ORIGINALLY PROPOSED DECK
- AMENDMENT TO PERMIT # 030900

DEPT. OF BUILDING INSPECTION
CITY OF PORTLAND, ME
MAR 2 2004

AMENDMENT TO ORIGINAL PERMIT # 030900

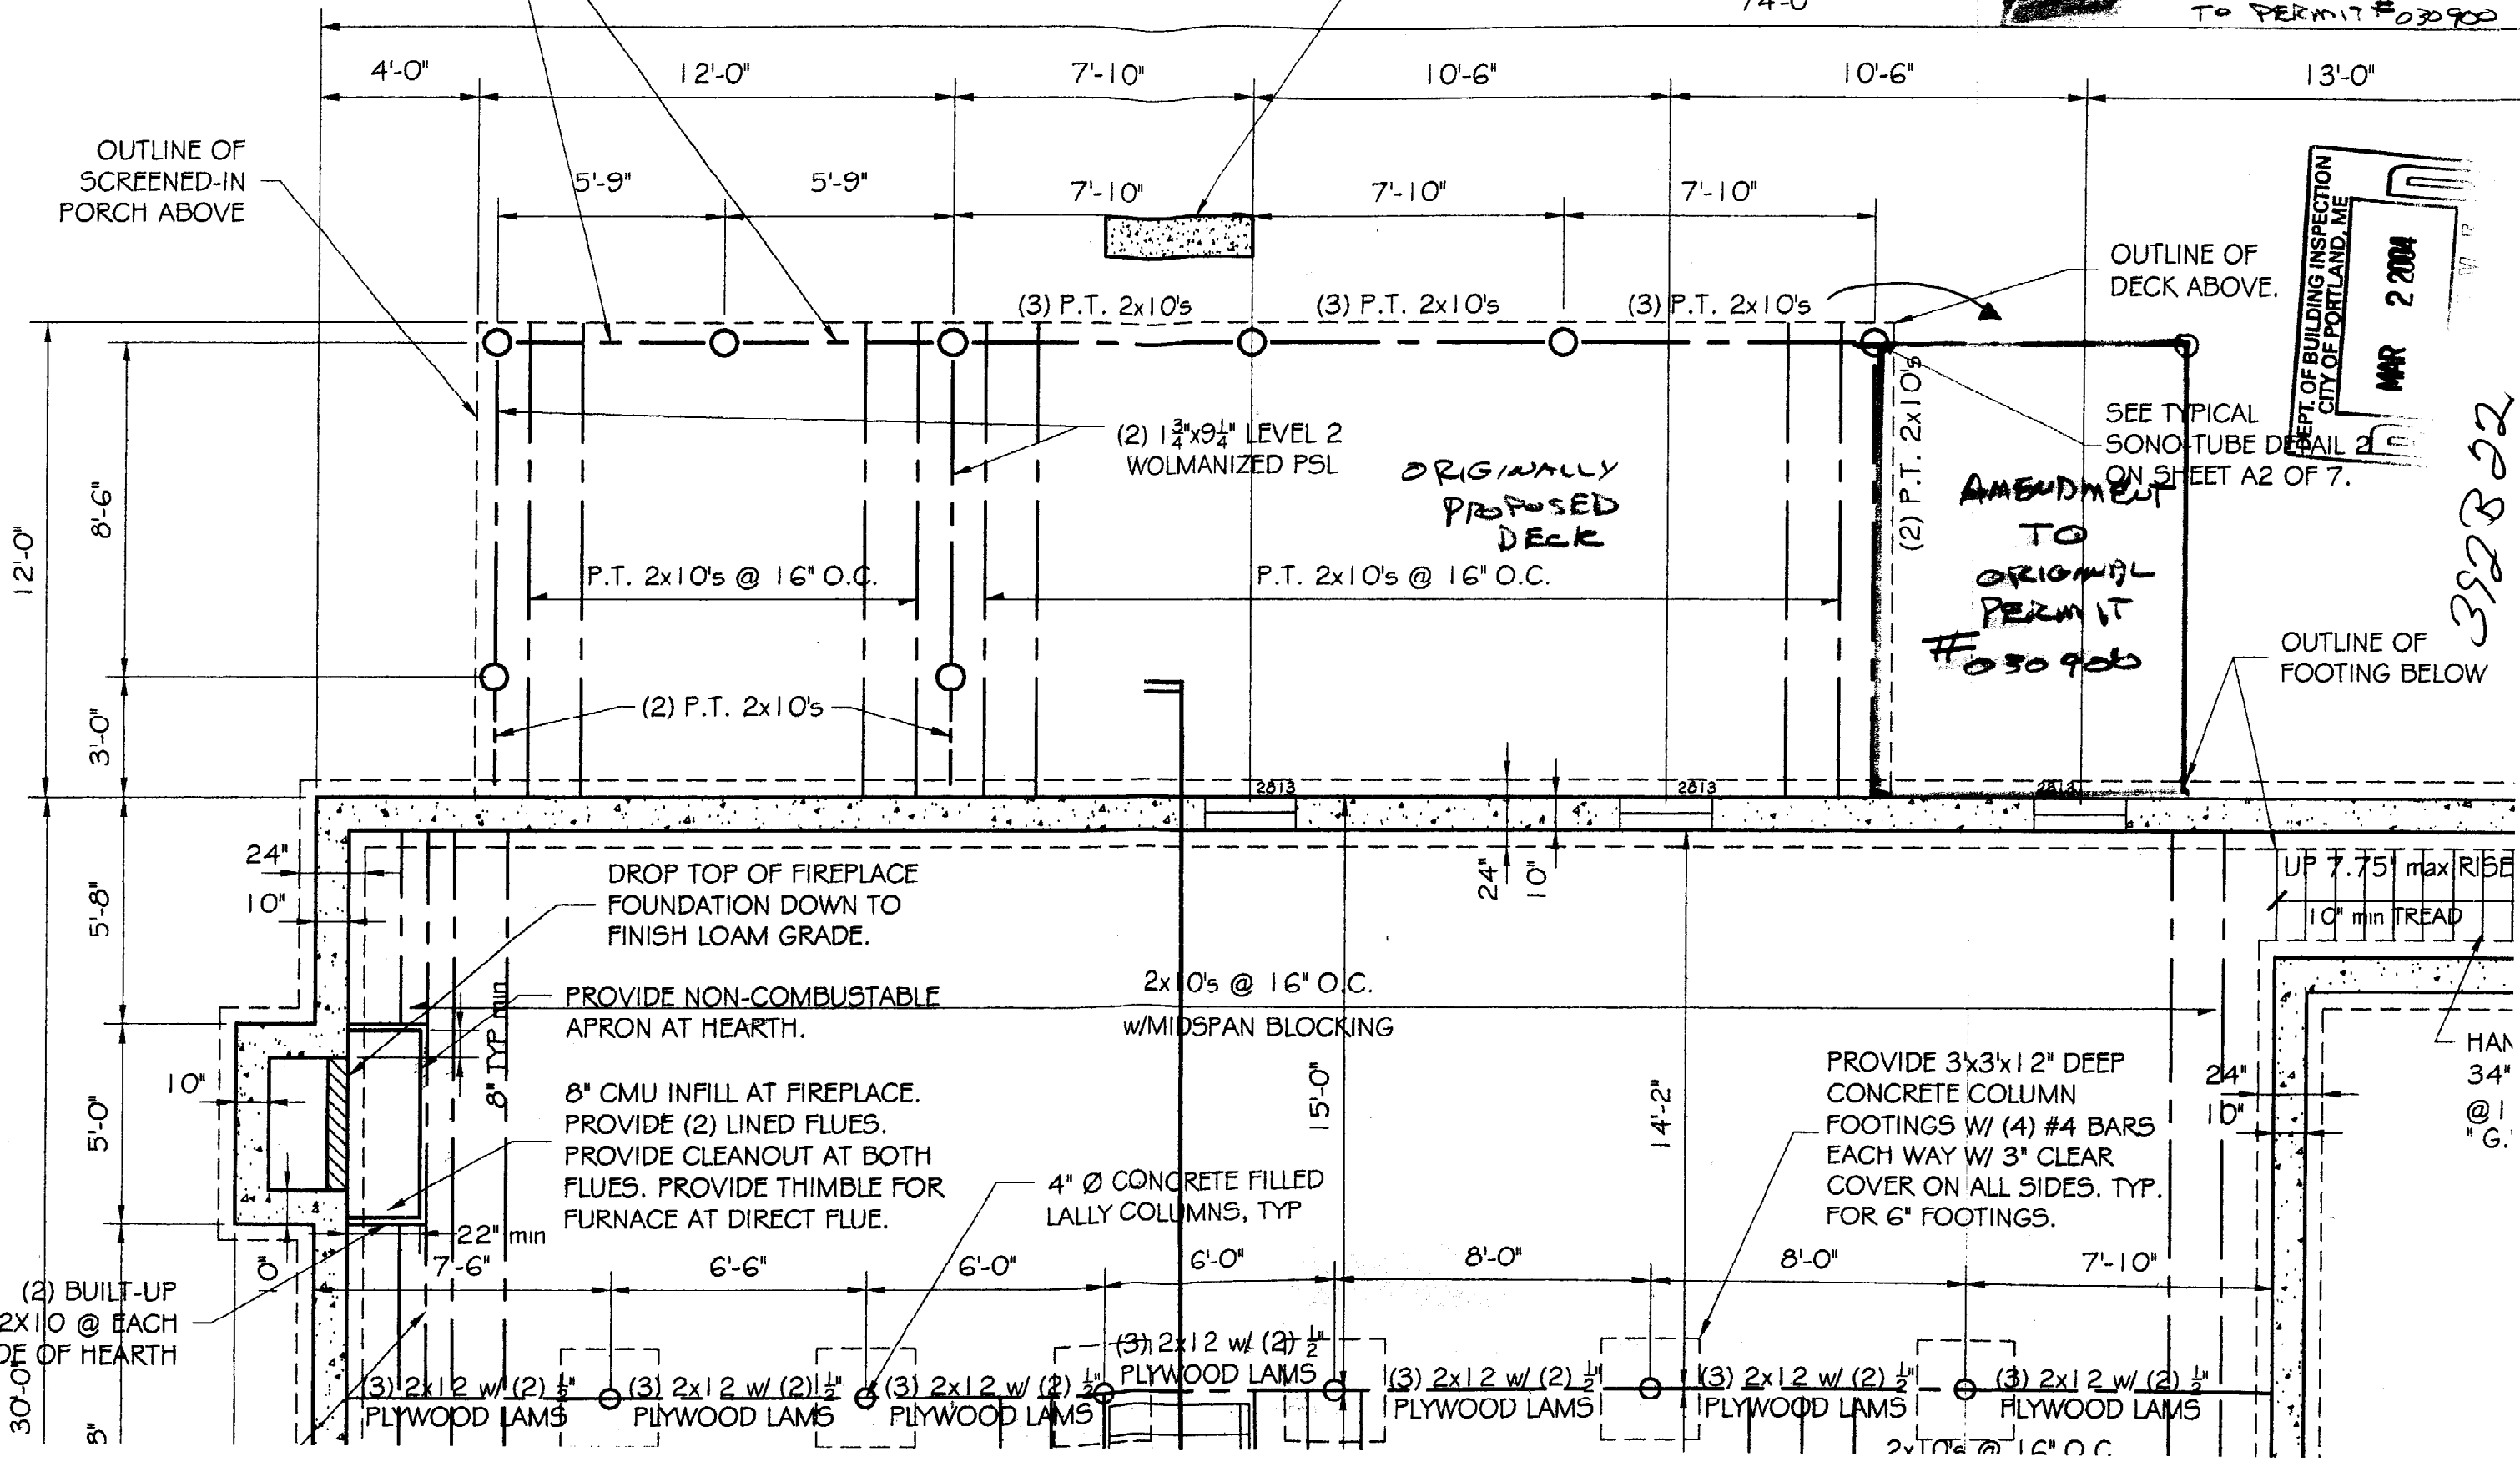
PROVIDE 48" x 12" x 12" DEEP CONCRETE PAD FOR SUPPORT OF DECK STAIRS. VERIFY LOCATION IN FIELD

SEE TYPICAL SONO-TUBE DETAIL 2 ON SHEET A2 OF 7.
